The City of Spartanburg Design Review Board

AGENDA

PROJECT/ADDRESS/ TAX IDMagnolia Residences/W. Broad Street/7-12-30-4248990;
7-12-30-4153140; 7-12-30-4045895; and 7-11-39-4948449**PROJECT NUMBER**

REVIEW STATUS – continuance - Full and Final**COPIES TO**

PREVIOUS 2/10/25 DRB EXTERIOR ELEVATION
(NO RENDERING PROVIDED IN PREVIOUS SUBMISSION.)

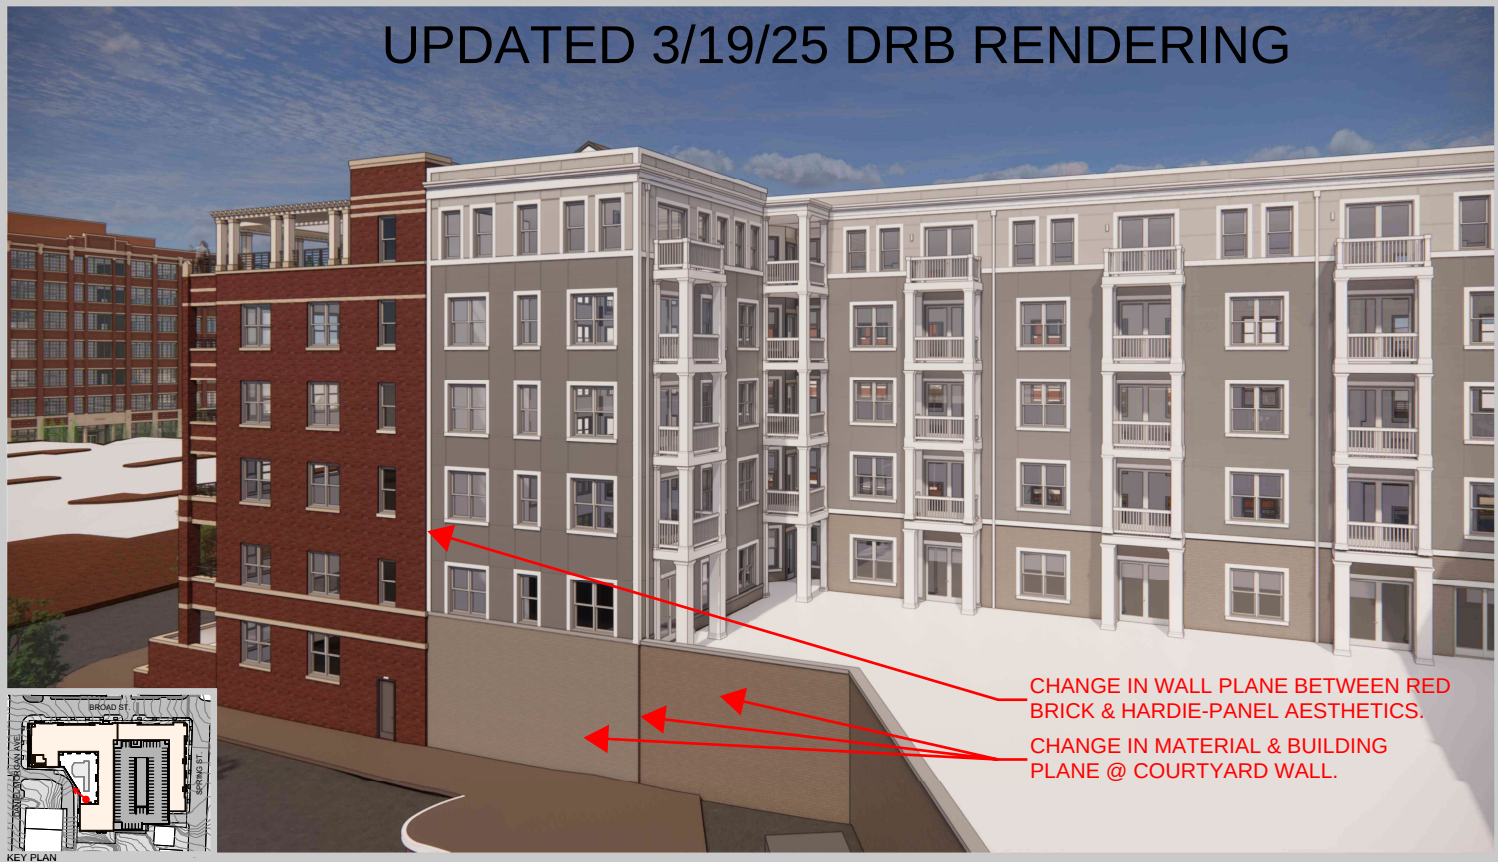
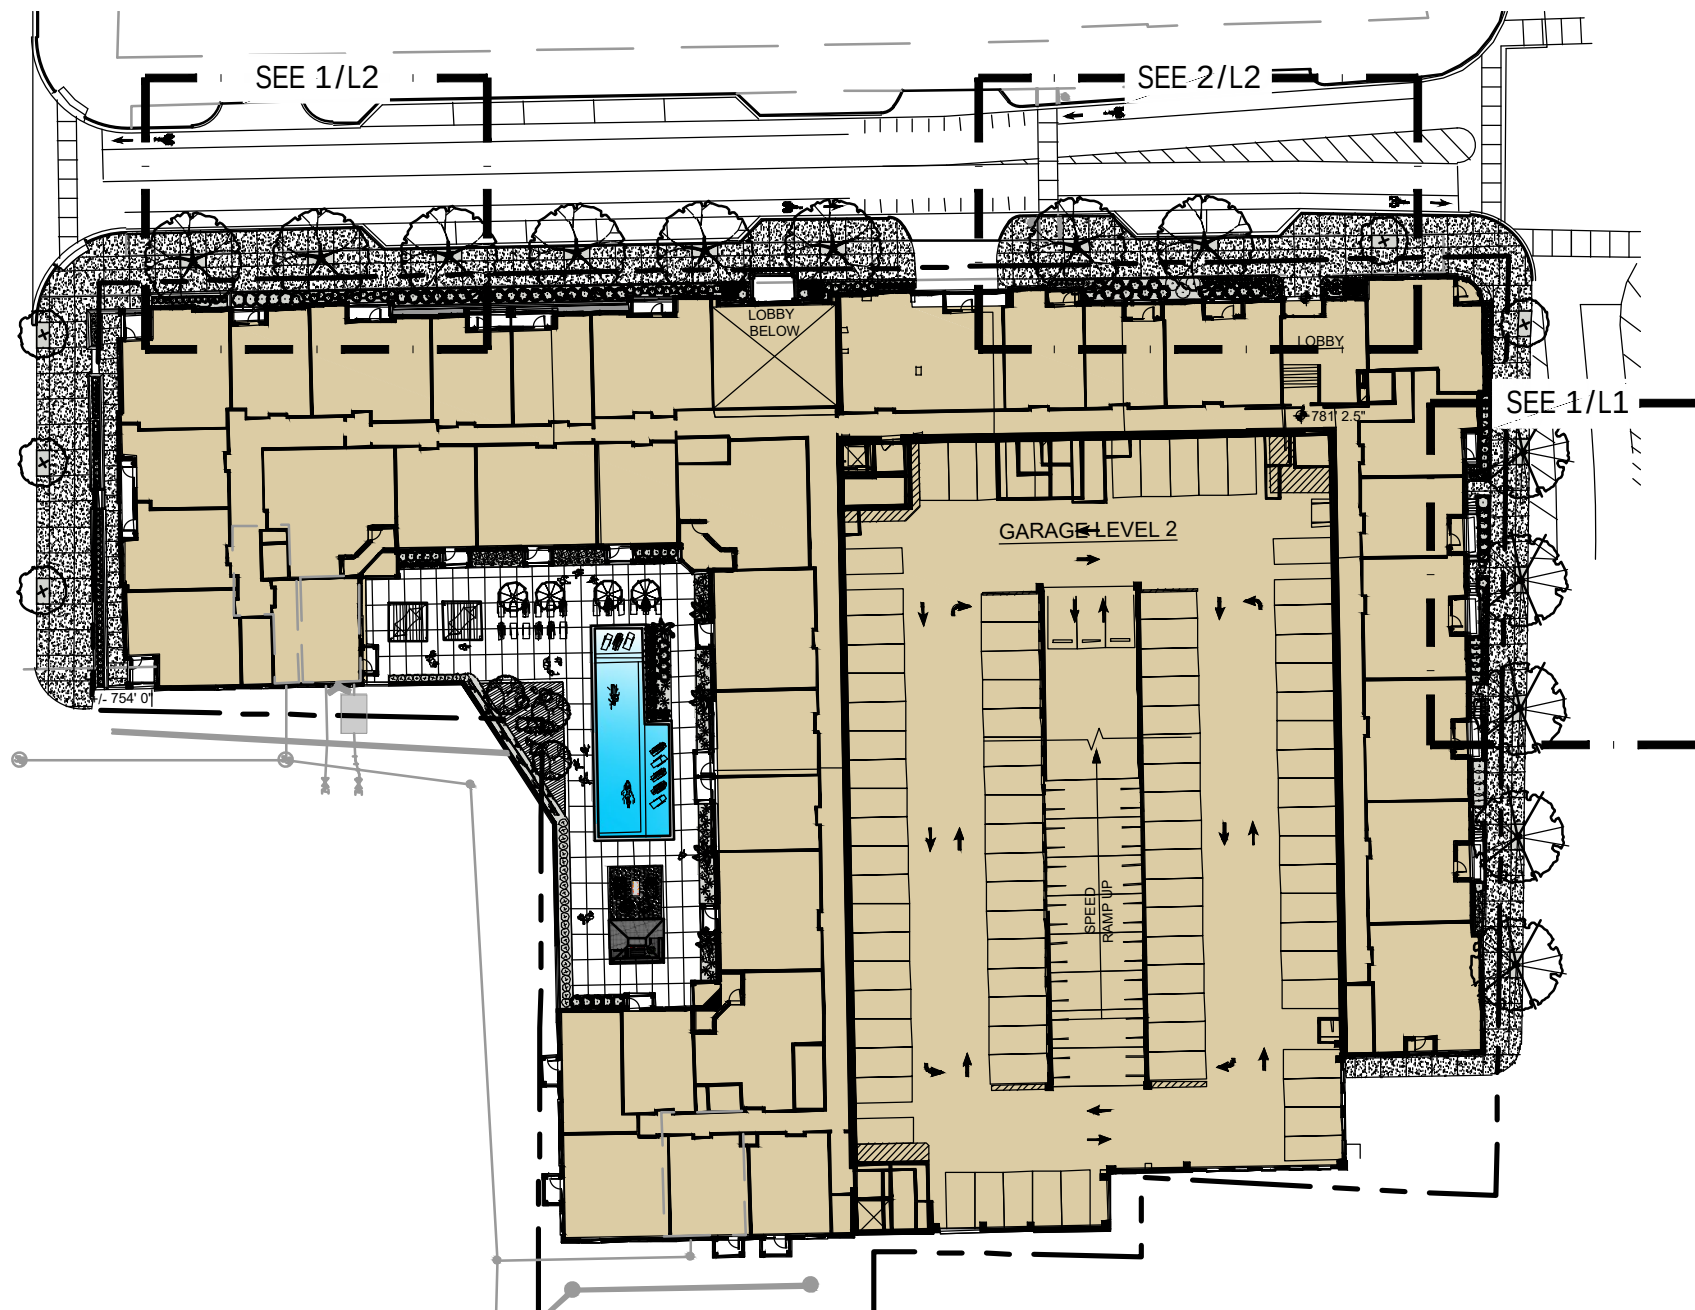
a. An additional color 3D rendering from the perspective of Daniel Morgan facing northeast, looking north along Daniel Morgan and east on Hub-Bub Way, at the building corner where the rooftop amenity is located.
